**RE: Subgrade Inspection for Lot # 80 Woodside Ridge – 317 NW Ambersham Dr
Lee's Summit, MO 64082 – Permit # PRRES20210283**

On April 1, 2021, a special inspection was performed by Residential Engineering Services, LLC (R.E.S.) at the above referenced property. The purpose of this inspection was to determine structural adequacy of the existing soil for construction of concrete foundation.

SPREAD FOOTING
DETAIL
N.T.S.

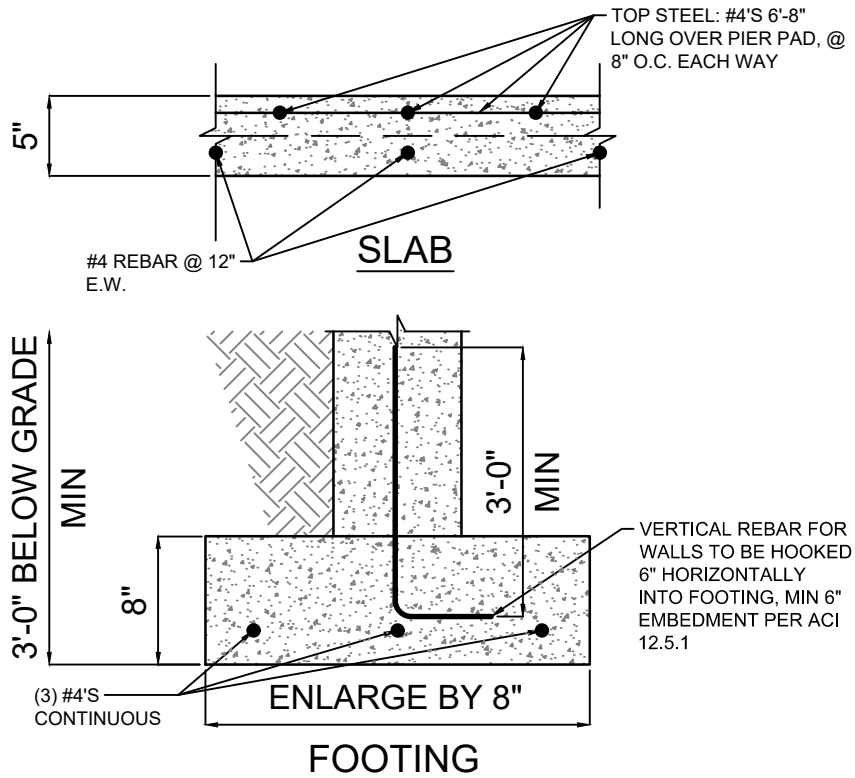
- The soils observed at footing elevation were silty clay; light brown; high plasticity and dry.
- Probes and penetrometer readings indicated that the soils do not have sufficient bearing capacity for the loads applied by foundation per permit plans.

- RES recommends that the footings on the rear half of the lot be enlarged to 24"X8" with three (3) #4 rebar continuous (see attached specifications)
- Applicable basement pier pads in the area of concern shall be enlarged a minimum of 6" each way (i.e existing 30"x30" shall be enlarged to 36"x36", etc.) (see attached specifications)
